STAFF RECOMMENDATION
3926 Cambridge Avenue
August 16, 2017

Application: New construction—addition and outbuilding
District: Cherokee Park Neighborhood Conservation Zoning Overlay
Council District: 24
Map and Parcel Number: 10308018400
Applicant: Van Pond, Jr.
Project Lead: Melissa Sajid, melissa.sajid@nashville.gov

Description of Project: Application is to construct an addition that is taller and wider than the historic house. Application is also to construct an outbuilding. The outbuilding will not contain a dwelling unit. **Recommendation Summary:** Staff recommends disapproval of the addition finding that that the addition's height, scale, and roof form do not meet the design guidelines. Staff finds that the addition does not meet Sections II.B.1.a, II.B.1.b, II.B.1.e, and II.B.2. of the Cherokee Park Neighborhood Conservation Zoning Overlay design guidelines. Staff recommends approval of the outbuilding with the condition that staff approve the materials of the windows, doors, and roof color prior to purchase and installation, finding that the outbuilding meets Section II.B.1.h of the design guidelines. *The Commission does not have the authority to approve the use. This reco

DETACHED GARAGE ELEVATIONS

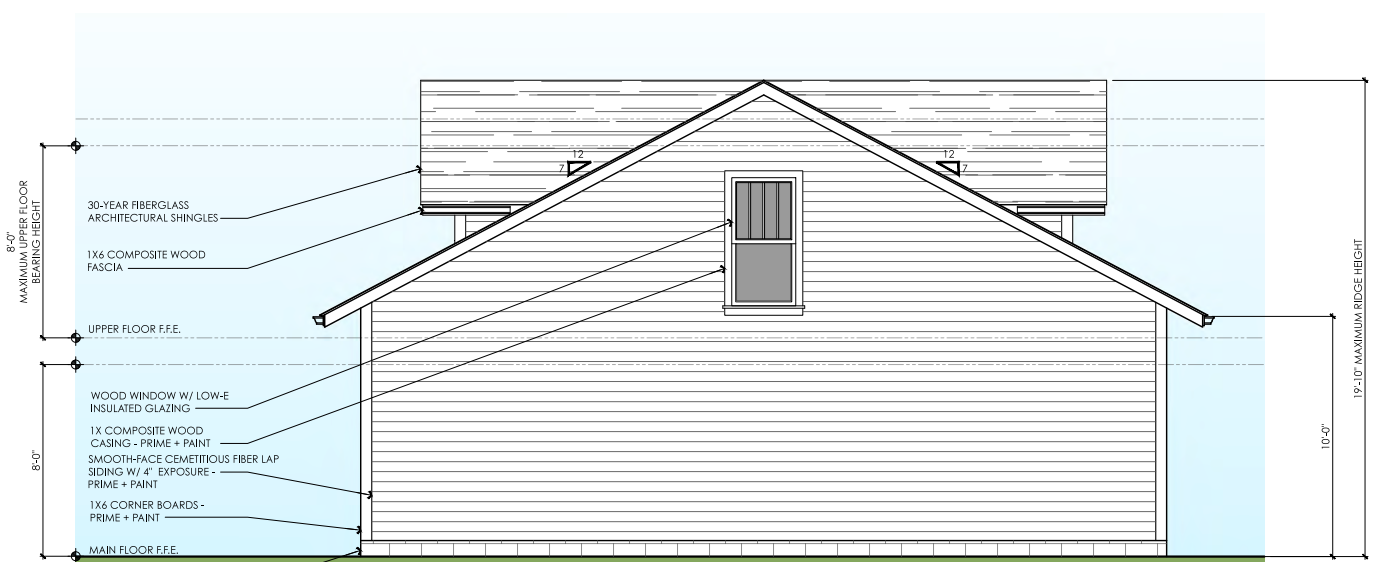
Since the form and slopes are similar to historic outbuildings, staff finds that the project's roof form meets Section II.B.i.1 of the design guidelines.

Design Standards: The accessory structure has a simple, utilitarian design that is appropriate for outbuildings. Its roof form, detailing, and form do not contrast greatly with the primary structure. The outbuilding is located in a minimally-visible location at the side and rear of the building. Staff finds that the design meets Section II.B.i.1 of the design guidelines.

With the staff's final approval of the windows and doors and roof color, staff finds that the known materials meet Section II.B.i.1. of the design guidelines.

Staff recommends approval of the outbuilding with the condition that staff approve the materials of the windows, doors, and roof color prior to purchase and installation, finding that the outbuilding meets Section II.B.1.h of the design guidelines.
